BELLEVUE HEIGHTS SUBDIVISION

RESUBDIVISION OF LOT 9

APPLICATION NUMBER 18 DATE December 6, 2007

DETAIL SITE PLAN

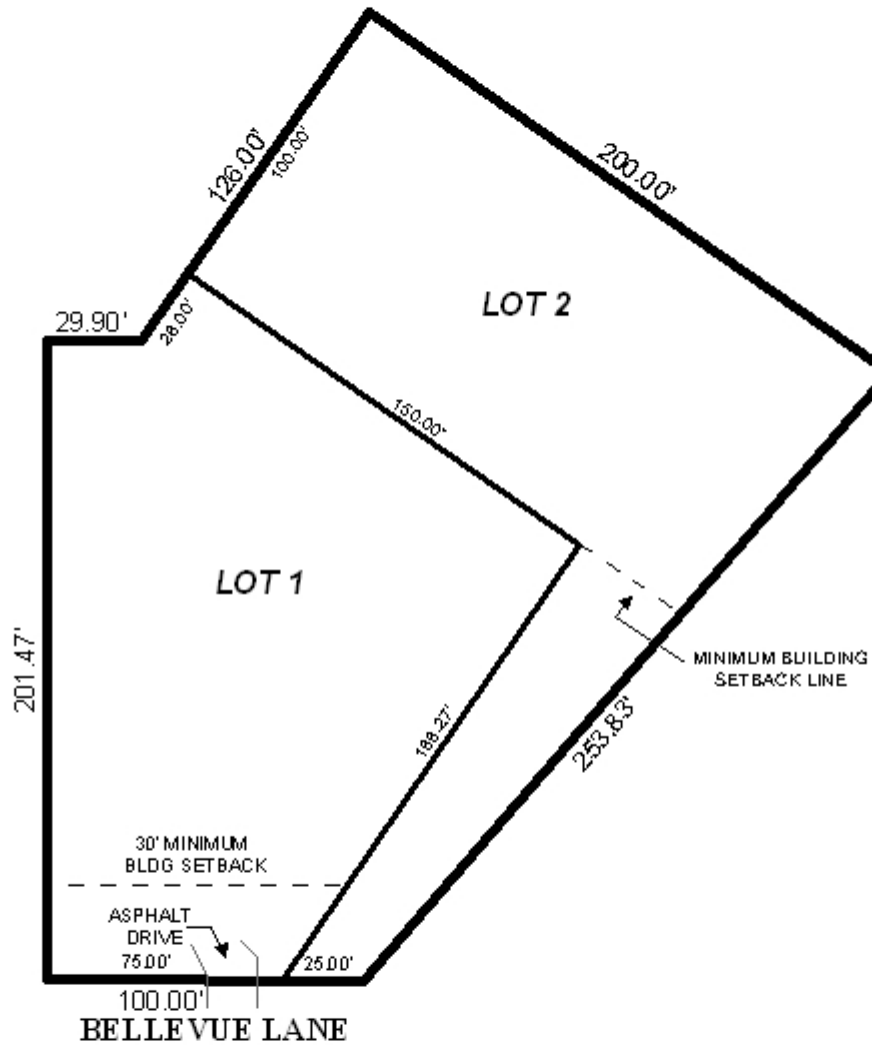
The site fronts Bellevue Lane, a minor street, with no depiction of right-of-way. If approved, the plat should be revised to provide a minimum of 25' from the center line of Bellevue Lane.

Lots 1 and 2 have approximately 75' and 25' of frontage, respectively, along Bellevue Lane. As a means of access management, a note should be placed on the final plat, if approved, stating that Lots 1 and 2 are limited to one curb each to Bellevue Lane, with the size, location, and design to be approved by Traffic Engineering and conform to AASHTO standards.

Proposed Lot 2 will be a flag lot with only 25' of frontage, which will require a waiver of Sections V.D.1. and V.D.3. of the Subdivision Regulations. Two flag lots were approved by the Planning Commission in 1981 for a site that fronts Lakewood Drive East, to the Northwest of the site under consideration. However, while those lots were approved, they are too far removed from the site in question, in another subdivision. Therefore, the proposed flag lot would not be characteristic of the immediate vicinity.

If approved, the minimum building setback line as depicted on Lot 2 should be moved back to at least 25' from where the "pole" intersects the "flag" portion of the lot. Setbacks for the rest of the lot must comply with the zoning ordinance.

If approved, the plat should also be revised to label each lot with its size in square feet, or the provision of a table with the same information is required.

There is a structure located on the proposed interior lot line. If approved, it should be demolished upon signing the final plat.
